SUBJECT: DISCUSSION BETWEEN TXU ELECTRIC AND THE U. S. NUCLEAR
REGULATORY COMMISSION (NRC) STAFF CONCERNING THE
COMANCHE PEAK STEAM ELECTRIC STATION (CPSES), UNIT 1,
STEAM GENERATOR TUBE INSPECTION

NRC Questions for the CPSES 1RF08 Outage Phone Call (4/4/01)

Comanche Peak 1RF08 Circ ODSCC +Pt Max Voltage Population

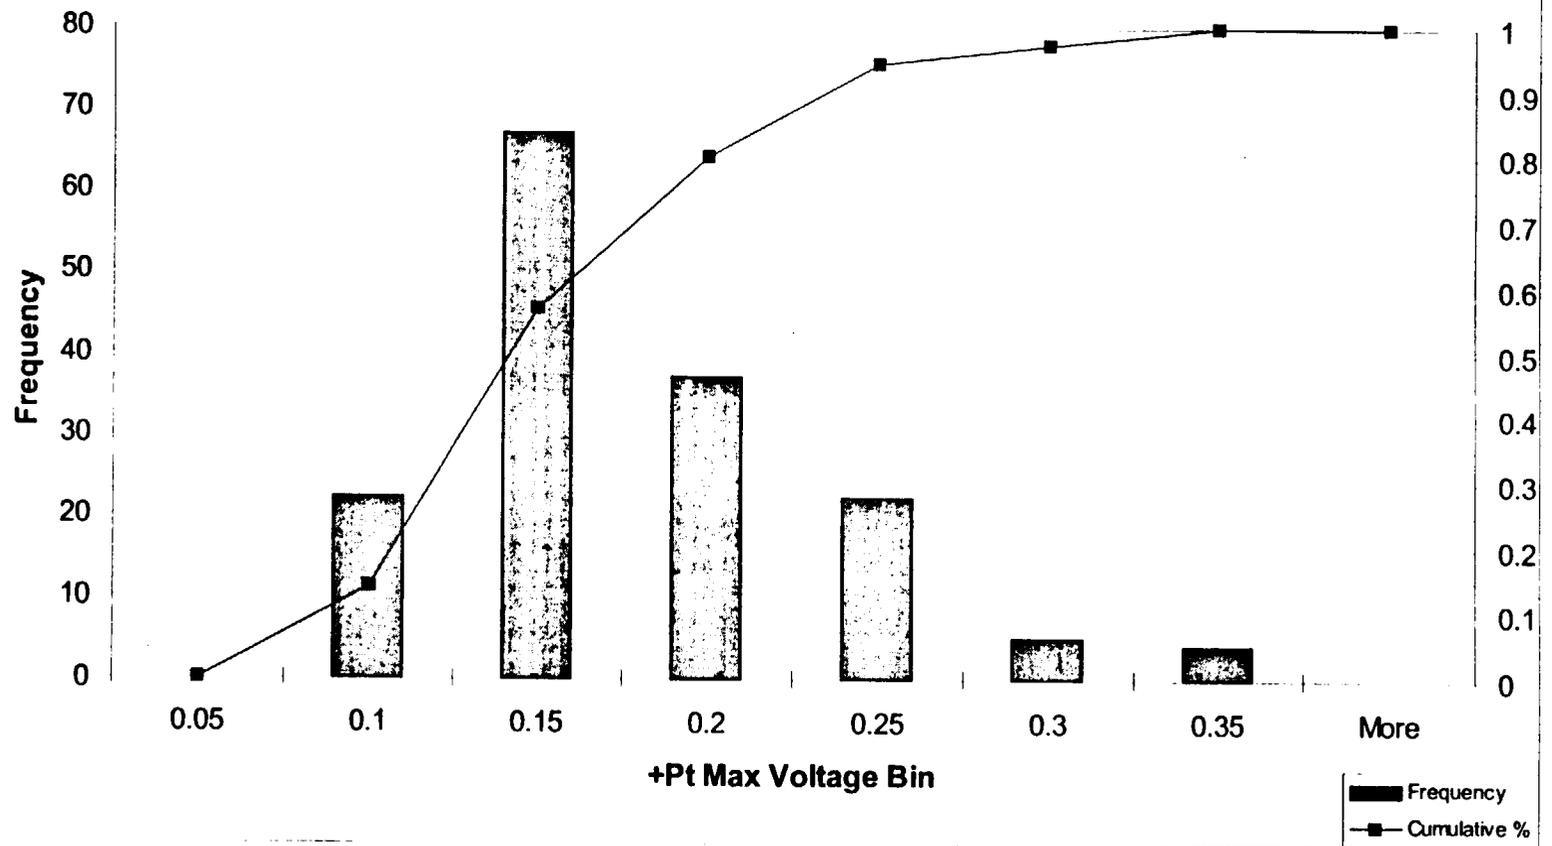
4. For analyzed EC results, describe bobbin indications (those not examined with rotating pancake coil (RPC)) and RPC/Plus Point/Cecco indications. Include the following information: location, number, degradation mode, disposition, and voltages/depths/lengths of the most significant indications?

Profiling of ODSCC circ flaws has not been performed. Conservative estimation of limiting PDA suggests a burst pressure of 6414 psi with material properties and sizing uncertainty modeled at 90% probability, 50% confidence levels.

Mid-Range vs High Freq Noise Values: Tube by Tube Comparison 90° Analysis Window at Extrados, Intrados, and Flanks

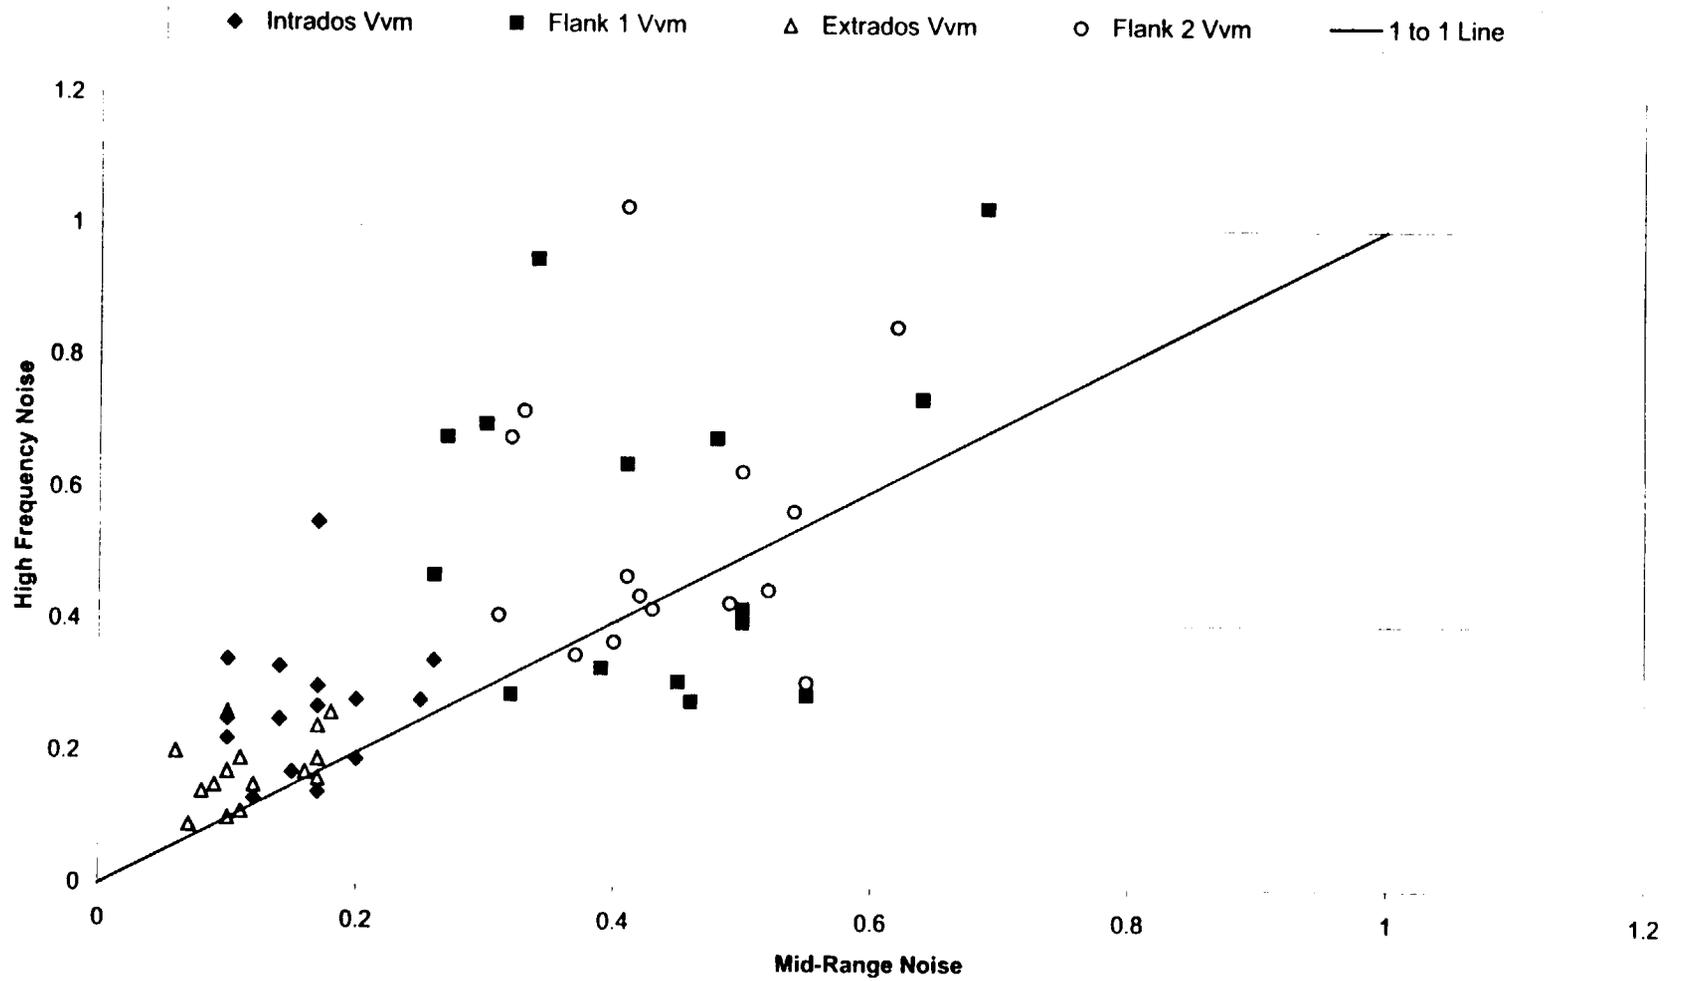
b) the actions taken to ensure that data noise levels are acceptable

Noise levels were evaluated prior to the outage using guidance developed by Westinghouse. This evaluation concluded that some high frequency +Pt examination should be conducted. The plant average peak to peak and vertical maximum values were slightly higher than the ETSS 96511 data. At 95% confidence, the plant data was slightly less than the ETSS 96511 data. The high frequency examinations were performed on those tubes with the largest noise components, up to a sampling level of 20%. For the conditions specific to Comanche Peak 1, the high frequency +Pt is not expected to produce a condition where PWSCC detection in the U-bend region is increased. This is based on the negligible OD deposit condition at CPSES 1, due to chemical cleaning at 1RF05 and application of scale conditioning agents at each outage. Further evaluation shows that for the area of the tubes most likely to develop PWSCC, namely the extrados region, the noise levels are substantially low that adequate detection capabilities are provided using the mid-range +Pt. For

the 1RF08 inspection, noise levels are slightly reduced compared to the 1RF07 data. Evaluation of high frequency +PT noise levels indicates that vertical maximum noise levels are increased for the high frequency coil compared to the mid-range.
